Watermaster Review Form:

Water Right Transfer

Transfer Application: T-14367

Applicant Name: Brown Saylor Ranch, LLC

**Cert:2679 approximate Place of Use
overlaid on Oregon Statewide
Imagery Program 2022 Aerial
Imagery**

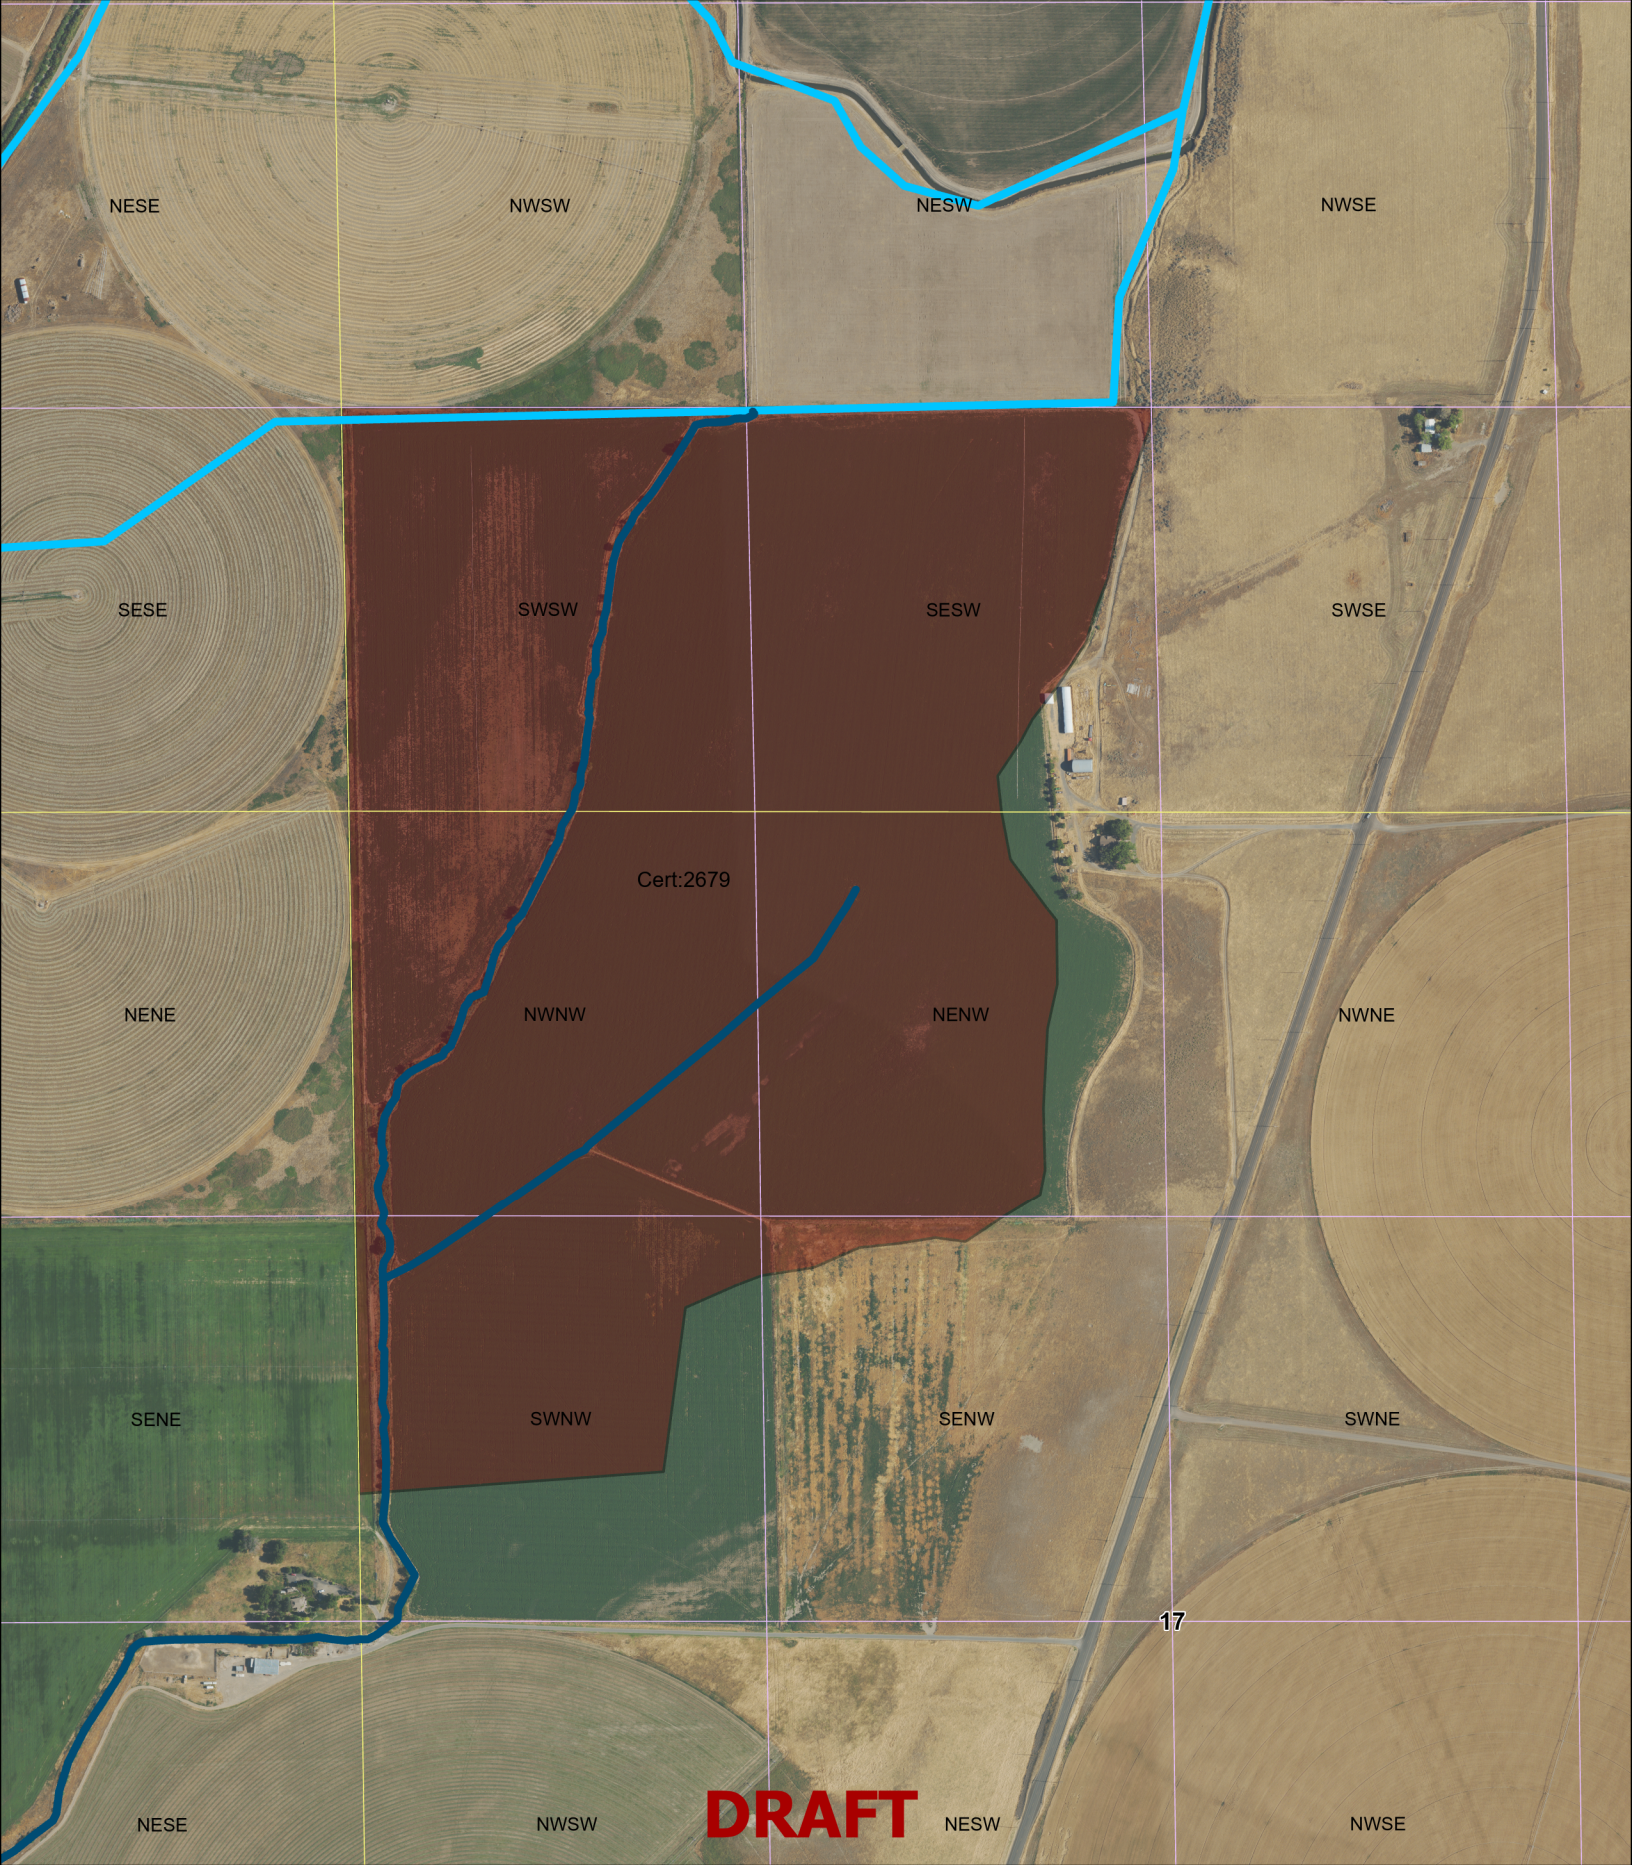
I have concerns that the original POU (from lands) will continue to be irrigated. The reason being is that this is a flood irrigated property and the "from" lands are on the downstream side resulting in flood water traveling across the field on to the "from" lands.

The applicant is also irrigating lands within the NENW of 17 that do not have a water right according to maps created by OWRD. They need to also correct this acreage or make plans transfer water rights onto these lands or cease irrigating. It was my understanding that they were going to address this during the transfer process. See email regarding mapping error.

Totalizing flowmeter must be installed and is required as part of this transfer.
